PREVOST

SAFETY RECALL

Sr98-32A

DATE : September 1998	SECTION : 06
SUBJECT : INSPECTION OF STARTER AND BATTERY CABLES

FIGURE 1 : STARTER CABLES

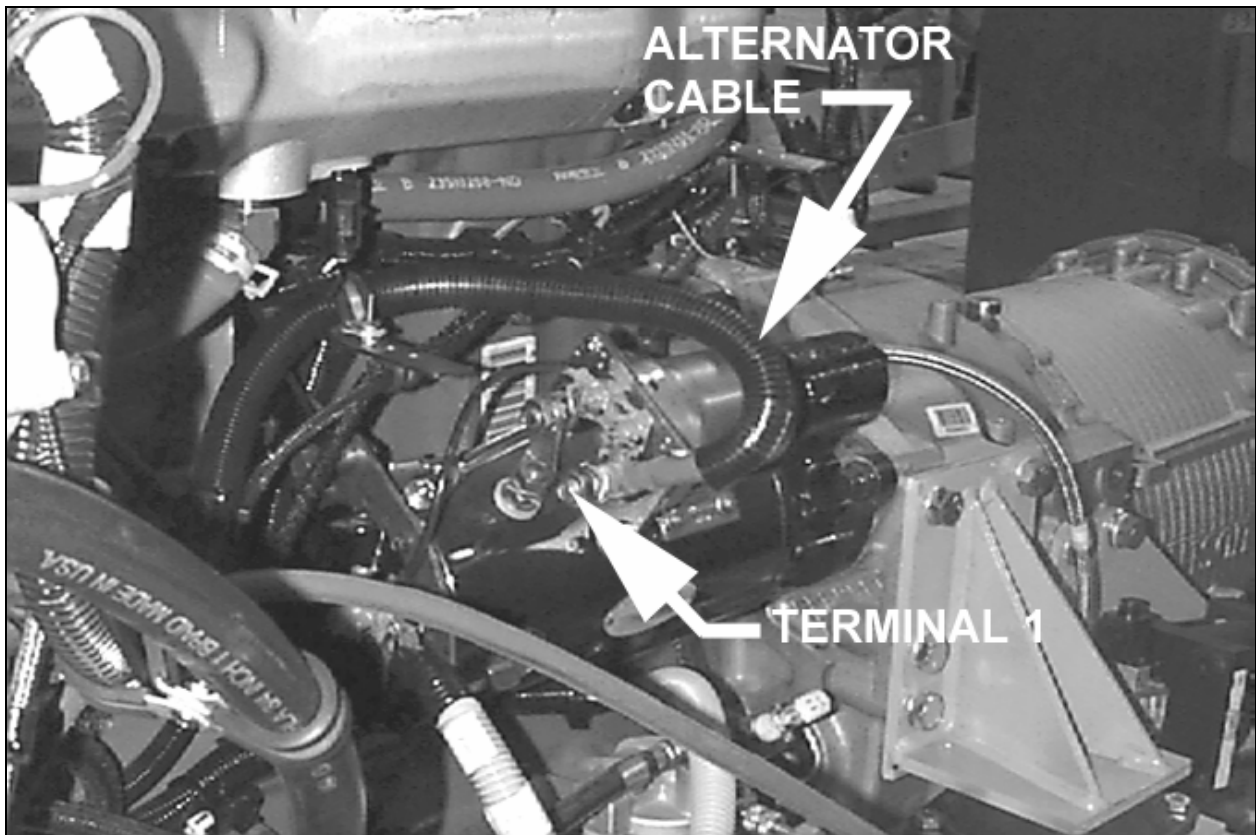
On the above-mentioned vehicles, wrong installation or incorrect torquing of starter cable fixing nuts may have occurred. Nuts may become loose after a period of time which could cause a short circuit or possibly a fire hazard.

1. Inspect alternator and battery cables connected to starter terminal # 1 (refer to figure 1).
2. Remove protective coating, loosen cable fixing nuts. Thoroughly clean cables and starter terminals.

3. Tighten first nut to 20 lbf?ft (27 N?m) torque.
4. Install alternator cable. Ensure alternator cable is positioned horizontally (3 o'clock). Refer to fig. 1.
5. Add two copper washers or one lock-washer.
6. Install battery cable to a 5 o'clock position, add one lock-washer and tighten to 27 lbf?ft (37 N?m) torque.

FIGURE 2 : MAIN POWER COMPARTMENT

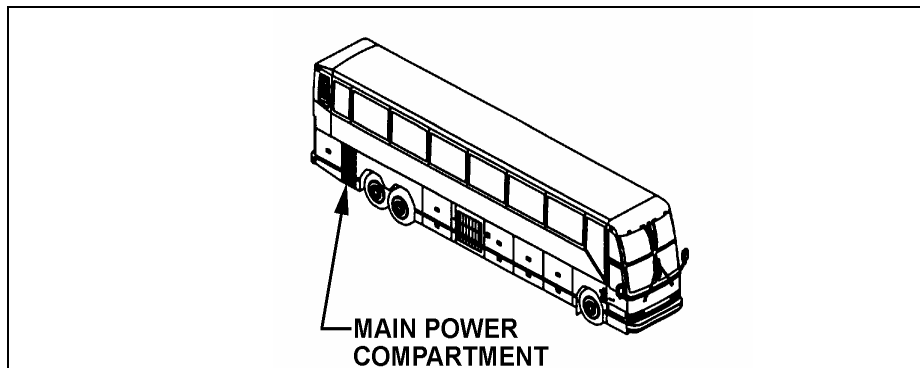
1. Main power compartment battery cables and cables near "Vanner" battery equalizer must also be checked to ensure they are sound. Open main power compartment door (refer to figure 2).

FIGURE 3 : MAIN POWER COMPARTMENT

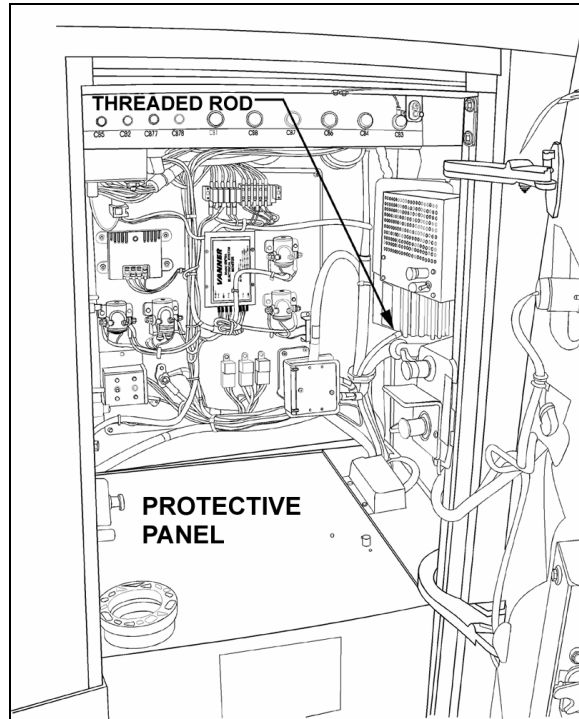
2. Ensure no cables are rubbing against threaded rod located underneath "Vanner" battery equalizer (refer to figure 3). Secure cables using cable ties if required.

FIGURE 4 : BATTERIES

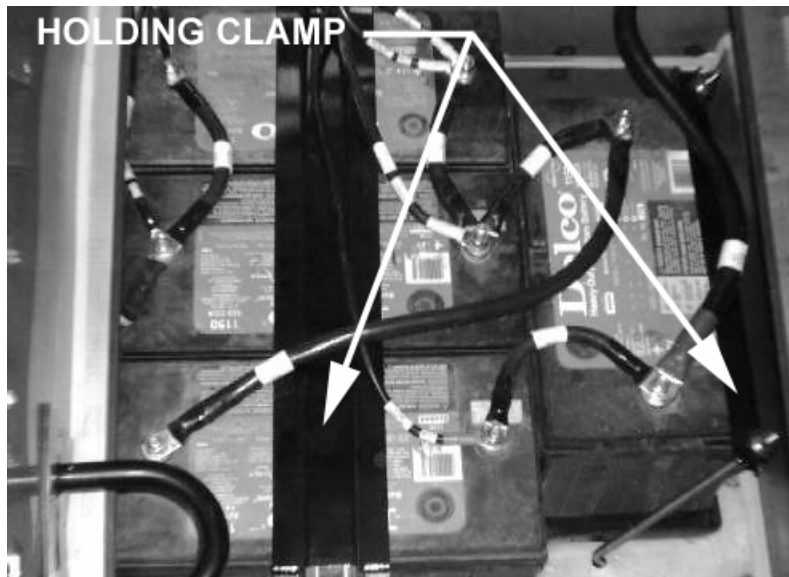
3. Remove battery protective panel and verify that cables are secure and in good condition, tighten if needed (torque is indicated on battery label) (refer to figures 3 and 4). Also check that holding clamps protective coating is present and in good condition. Reinstall panel and close the door.
